Holyhead Port Expansion Environmental Statement Addendum

Client: Stena Line Ports Limited

Reference: PB6108-RHD-ZZ-XX-RP-Z-0001

ES Completeness Report from The Planning Inspectorate on the HRO Application (DNS/3234821)

Figure 4-2 UKCP18 model grid used to derive sea-level rise projections for Holyhead.

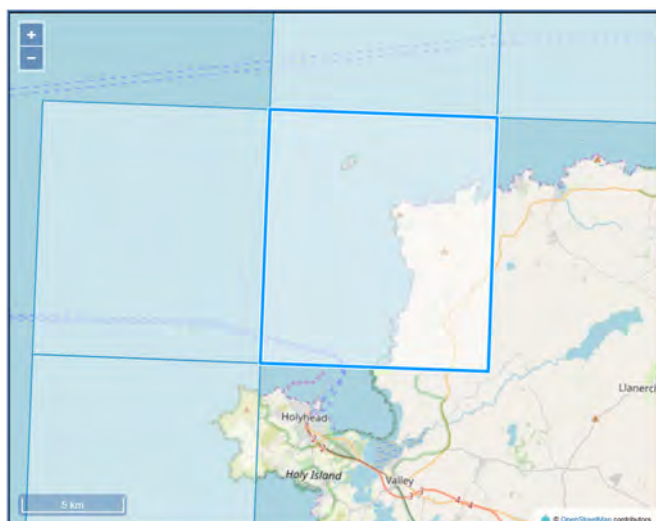
CP15	NRW	There is currently no discussion of climate change within the ES chapter, it has been considered in the wave modelling but should be discussed more broadly.	A broader discussion on the effects of climate change is provided in Section 4.2.3 .
CP16	NRW	Section 8.5.8. As raised previously, we note that wave data collected was only over a six-month period and over 10 years ago. It has been shown through the wave modelling however that at the worst-case scenario 330deg and for a 1:1000-year scenario with climate change there is still negligible impact on wave heights and therefore NRW Advisory still thinks this is an omission but one that can be resolved through the modelling and EGA.	The older wave data presented in <i>Section 8.5.8 of the ES</i> was only used as part of the baseline description of the area with no intent for use in the wave model. The wave model used is well-established and was initially developed for the Holyhead Breakwater PAR study (modelling completed in March 2017), where the offshore wave conditions were acquired from the Met office, provided as three-way frequency wave tables based on the 35 year remap" wave hindcast data.

The UK Climate Projections (UKCP18) user interface for the model grid cell that covers Holyhead Harbour is shown in **Figure 4-2**. UKCP18 relative sea-level rise estimates use 1990 as their starting year and are based on the IPCC 5th Assessment Report. They are available for low (RCP2.6), medium (RCP4.5) and high (RCP8.5) emissions scenarios and presented by UKCP18 as central estimates of change (50% confidence level, 50%ile) in each scenario with an upper 95% confidence level (95%ile) and a lower 5% confidence level (5%ile).

Figure 4-4 Model extent covering the Irish Sea (yellow star indicates the study site); brown dots showing bathymetry data points.

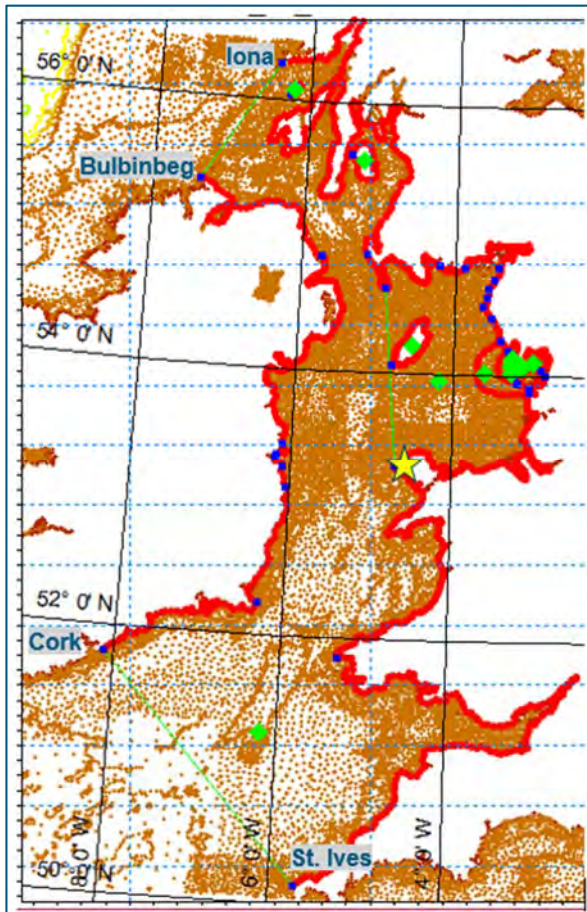
CP19	NRW	C2 - Hydrodynamic Modelling Report - Figure 3: Model extent covering the Irish Sea (yellow star indicates the study site) - the yellow star is in the Dee estuary, please amend. Difference plots don't show complete area of change – please revise spatial extent.	The position of the yellow star has been moved and shown in the new figure in Section 4.2.4 . The expanded difference plots are provided in Section 4.2.5 .
CP20	NRW	C3 – Sediment Plume Modelling Report As detailed in Appendix B Dredge Disposal Options Study, NRW does not support the application to use the sediment as infill. The total stated for land infill in previous reports is 640,000m ³ . However, this report only measures an impact of 546,909m ³ around 100,000m ³ less. There is also a discrepancy between the Sediment Plume Modelling Report and the Environmental Statement for the following totals: a. ES (m ³) Modelling report (m ³) b. Sediment Infill 640,000 546,909 c. Offshore disposal 1,260.000 Backhoe: 233,600 TSHD: 1,318,626 Total: 1,552,226 d. Total removal 1,900,000 2,099,135 4. No typical wave modelling is included in the assessment or storm events to assess sediment fate. 5. No dredge spill event is considered as a worst case scenario, NRW recommend this is included.	Section 3.2 describes the revised dredged sediment volumes, whilst the sediment plume dispersion modelling methodology is presented in Section 3.2.3 . No dredged sediment would be used for land-claim. The results of the revised sediment plume dispersion modelling are presented in Section 3.2.3.2 .

Figure 3 from the original hydrodynamic modelling report (*Appendix C1 of the ES*) is reproduced here (**Figure 4-4**) with the yellow star indicating the study site in the correct place.

Appendix C2

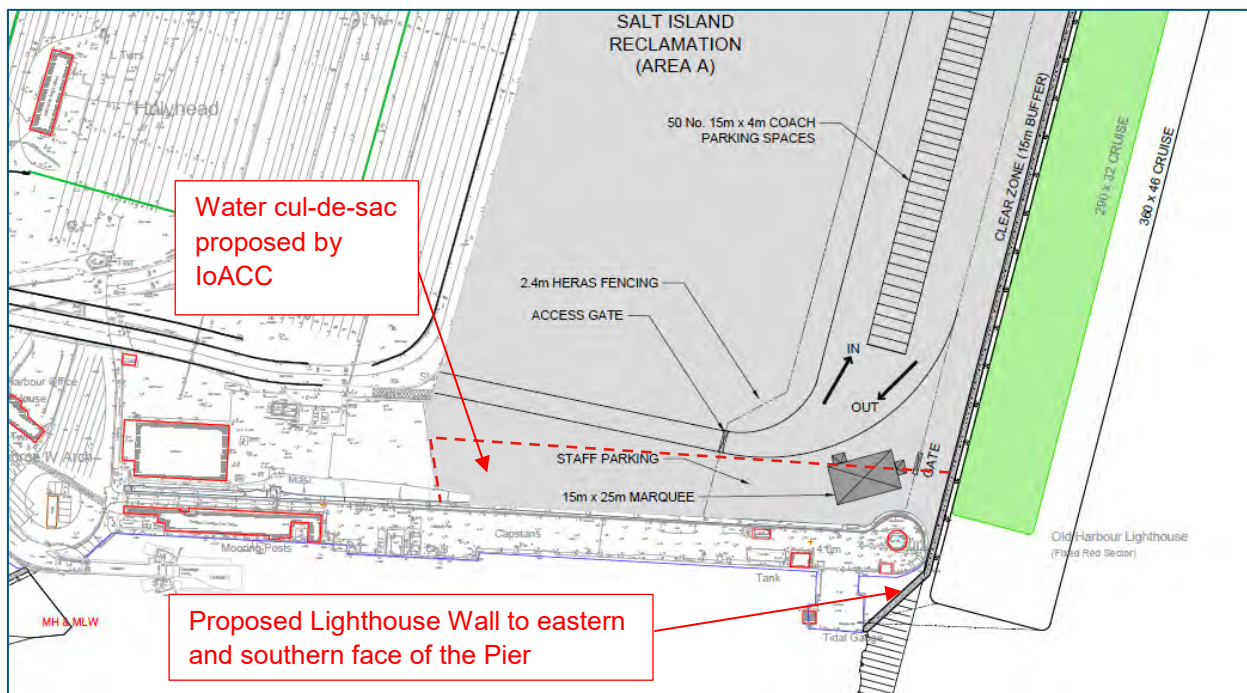
..the proposal for the Salt Island Expansion to directly abut Admiralty Pier and by doing so restrict much of the appreciation of the building and its function as a pier is of concern. The intention to introduce a new lighthouse wall to the South, that would further erode the setting and views of the listed building particularly from the direction of the grade II listed South Pier, is of equal, if not greater concern.

In providing a 'cul-de-sac' of water to remain between Admiralty Pier and the reclaimed area, as indicated on the above plan (**Figure 1**), the southern end of the berth would have to be stopped short allowing for a dredge slope back up to the existing seabed level at Admiralty Pier. The shortened dredge pocket and slope would therefore mean the berth would be 100m shorter than designed and could not accommodate the larger cruise vessels. Furthermore, an additional face of combi or sheet pile wall along the southern edge would have to be provided in order to support the material filling the reclaimed area, a function provided by Admiralty Pier in the current design.
